## ADDENDUM #1 TO MONTANA DEPARTMENT OF TRANSPORTATION INVITATION FOR BID #HWY-309727-RP

## MDT TRANSIT VEHICLES

## REQUEST FOR EXCEPTIONS/APPROVED EQUALS FORM

TYPE OF VEHICLE/EQUIPMENT: 35 Passenger Midsized Coach

Image 5: Bathroom Toilet

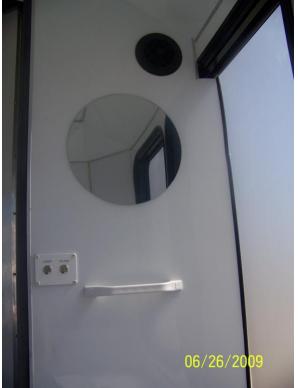
•	Please accept the Monogram		Furthermore,
				Model #32000-230 Recirculating		vendors can
				flush type w/ stainless steel insert		spec a holder
				w/ heavy duty toilet seat, toilet		for hand
				paper holder, trash can, mirror,		sanitizer in
				fiberglass enclosure and holder		place of the
				for hand sanitizer. See attached		stainless steel
14	23	5.7.10	Lavatory	pictures.	Yes	sink.
			,	Please accept overhead parcel		
				racks made by Pretoria with no		
				doors. We have these designed		
				for this bus and have been		
				installing for numerous years and		
				they have proven to be a strong		
				durable rack in coach use and still		
			Overhead	has that high end coach look. See		
15	24	5.7.11	Storage	attached pictures.	Yes	
				Please accept a .020 galvanized		
				steel for the barrier between the		
16	25	5.7.14	Floor	plywood and steel structure.	Yes	
10		3.7.14		Please clarify what you are
